# **Mount Piper to Wallerawang Transmission Line Upgrade Project**

Amendment Report

December 2025

Figure 5.1. Distribution of vehicle movements during the AM peak

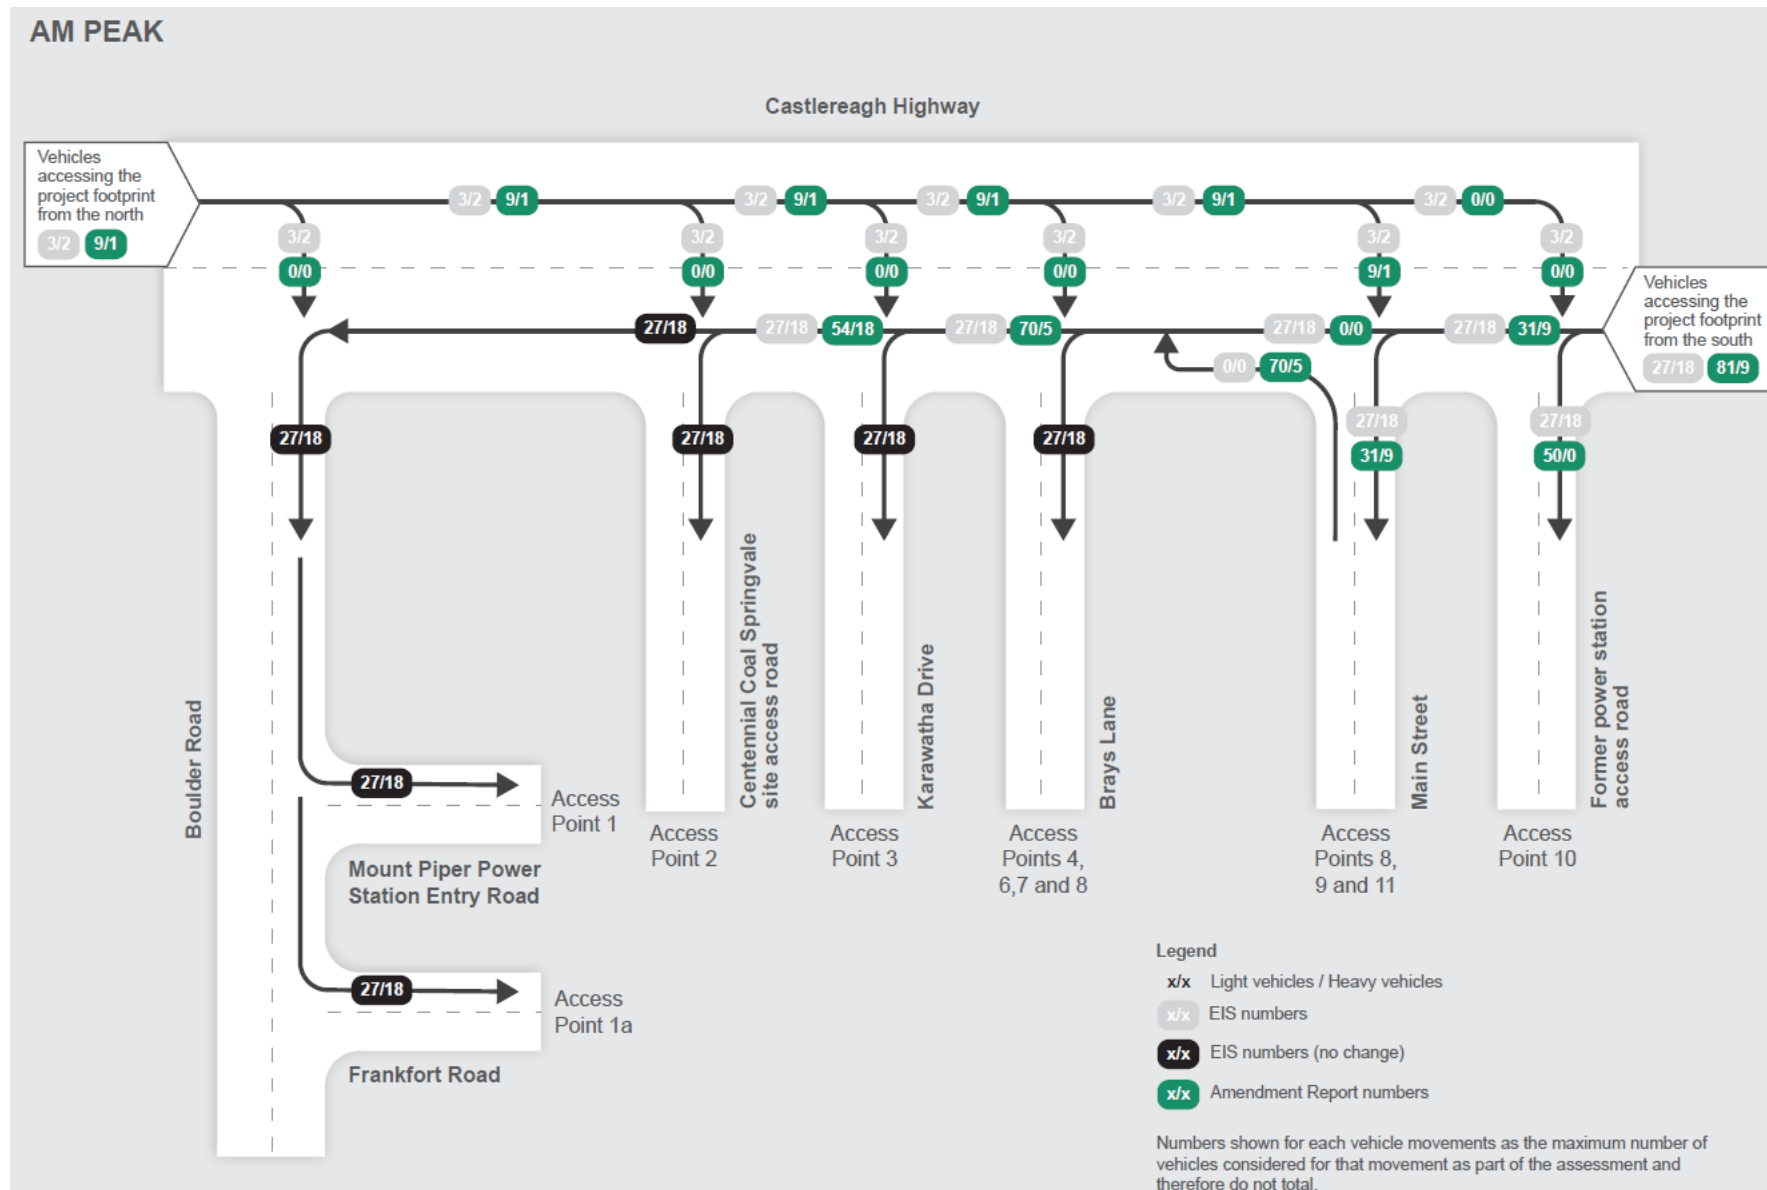
Figure 5.1 and Figure 5.2 provide a schematic illustration of the distribution of vehicle movements outlined in Table 5.11 for the AM and PM peak respectively, for both the exhibited project and the amended project. The movements in Figure 5.1 and Figure 5.2 are the maximum number of movements representative of peak construction period traffic generation in the Revised Traffic and Transport Assessment.

**Figure 3.7a - Construction compounds and access tracks**

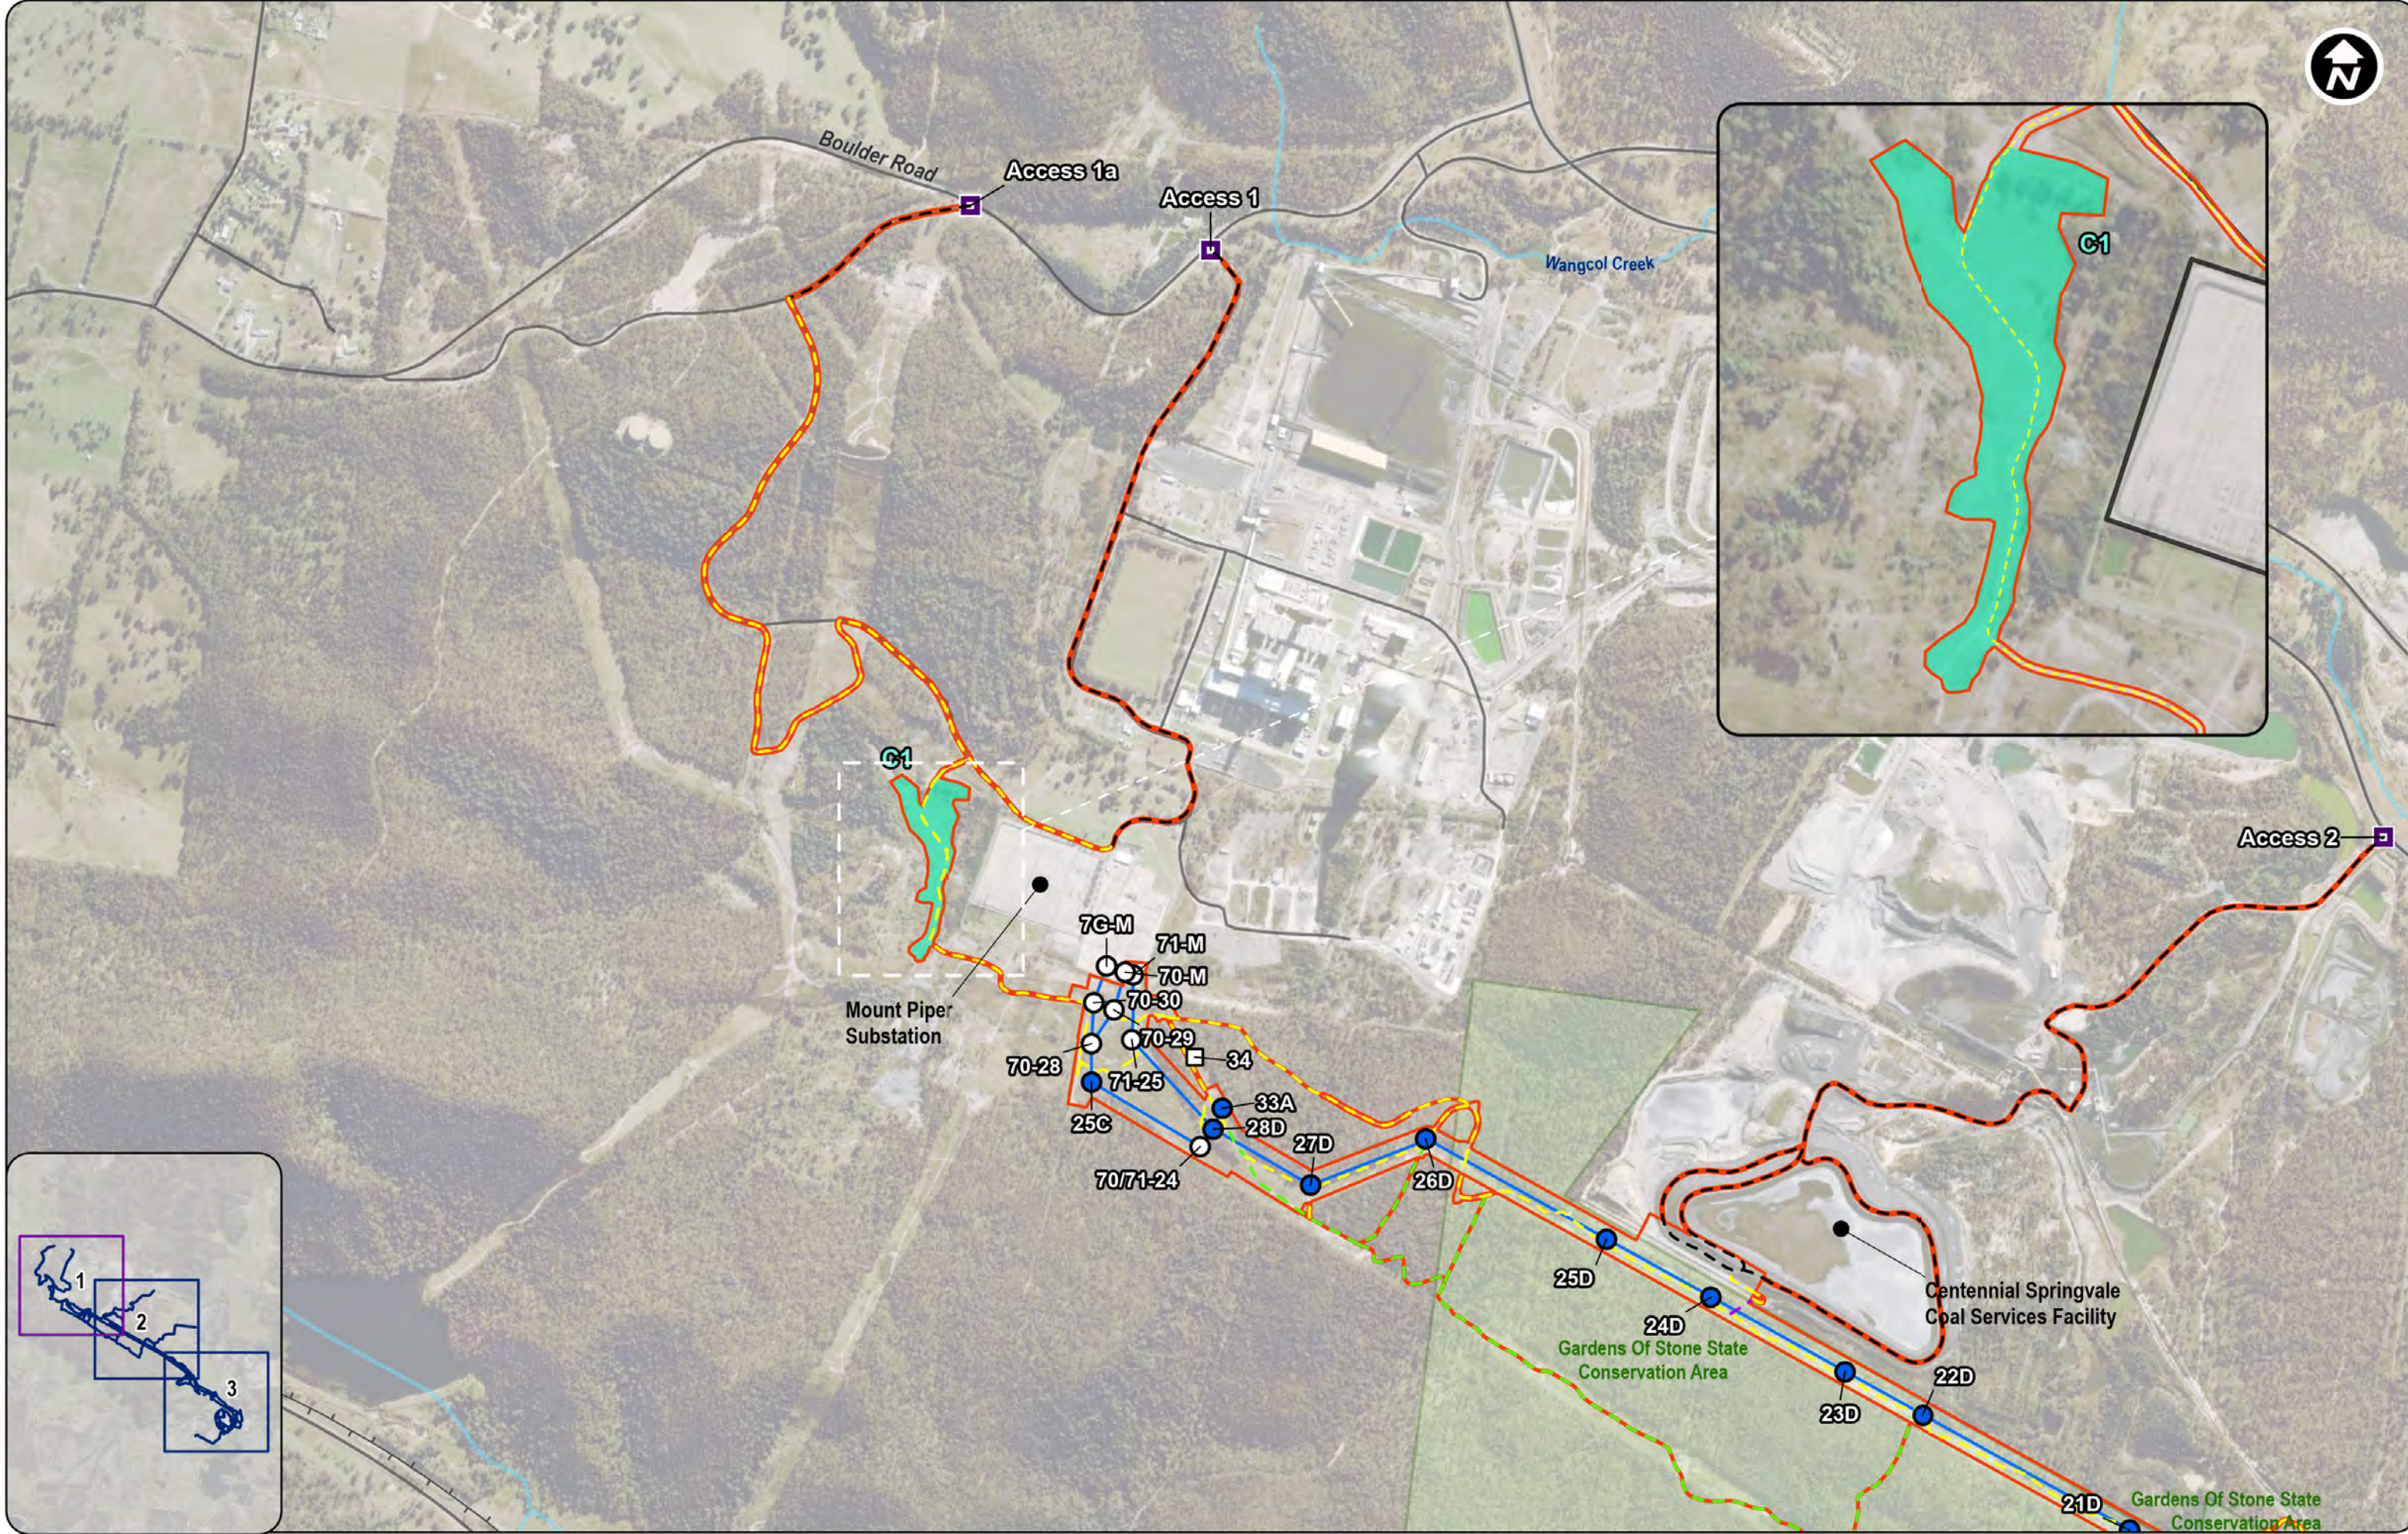
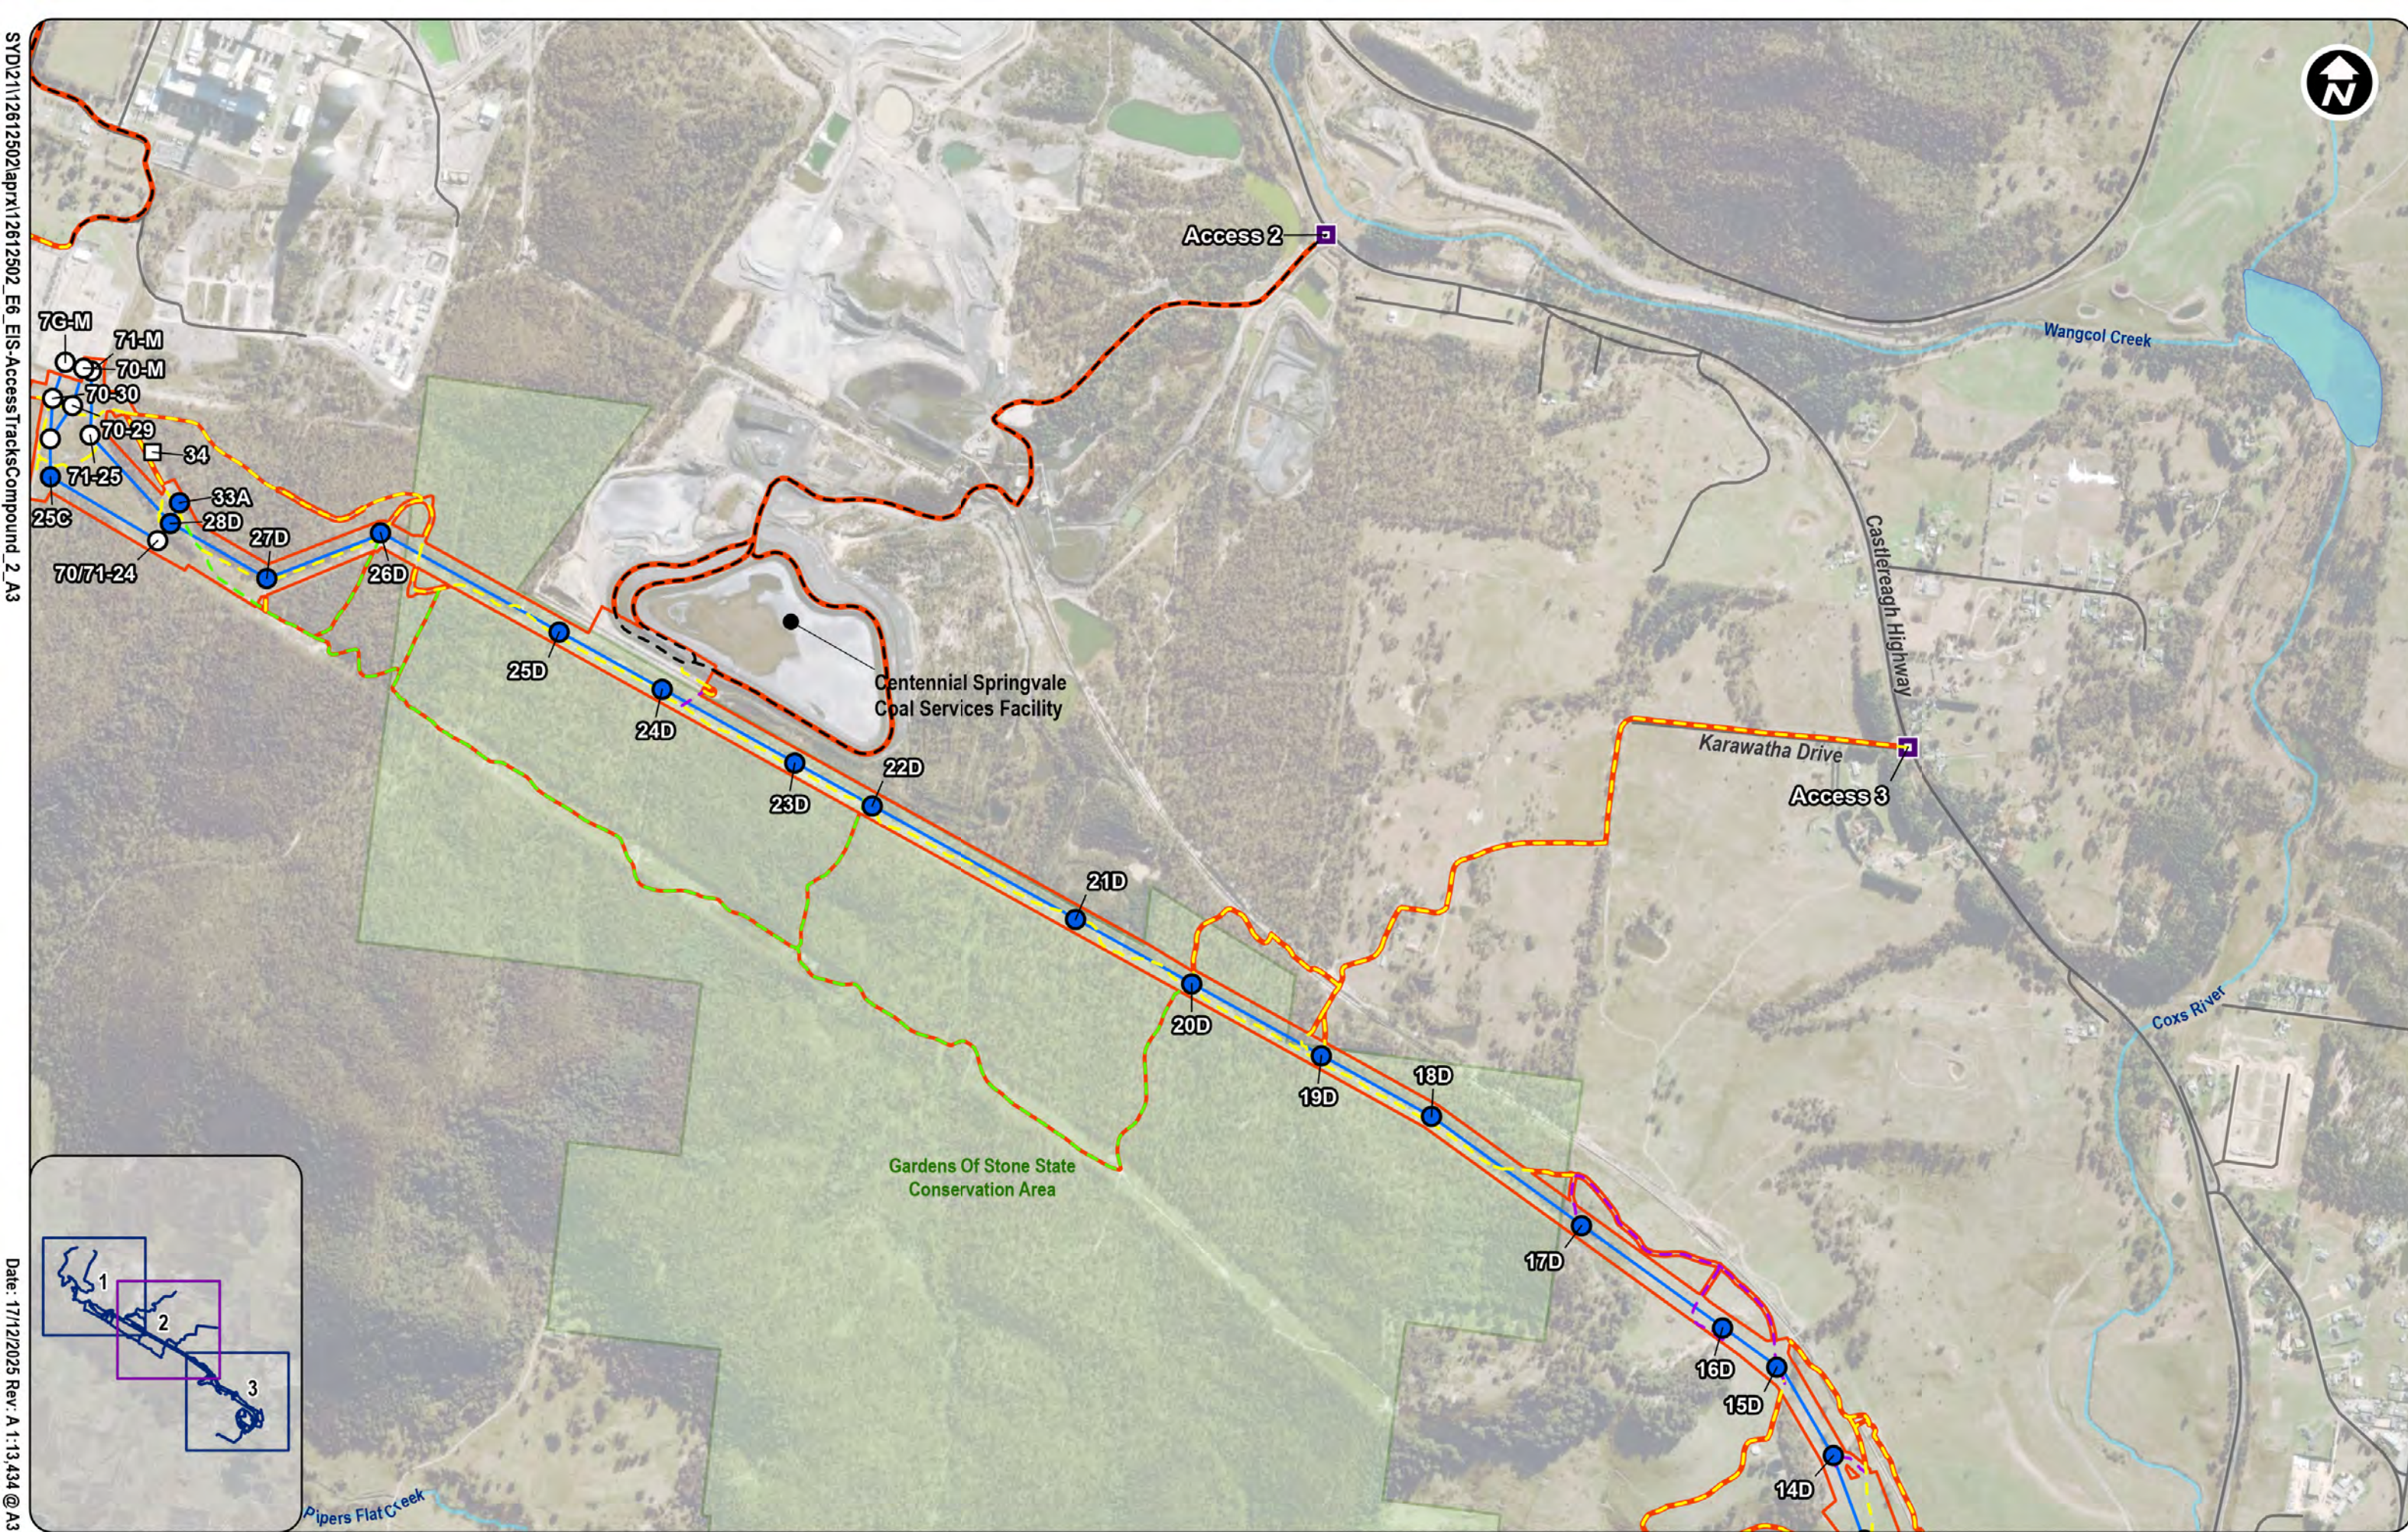
Of the total **1243** access points required for construction, ~~nine~~**eight** access points would be used for future operation and maintenance:

- Main access point **1** (~~4~~): Mount Piper Power Station entrance road off Boulder Road, Blackmans Flat
- Wallerawang access points **4, 6 and 7** (~~4~~) to (~~7~~): Brays Lane, Wallerawang
- Wallerawang access points **8 and 9** (~~8~~) and (~~9~~): Main Street, Wallerawang

- Wallerawang access point **10** ~~(10)~~: Castlereagh Highway, Wallerawang
- Wallerawang 330 kV substation access point **12** ~~(12)~~: Heel Street, Wallerawang.
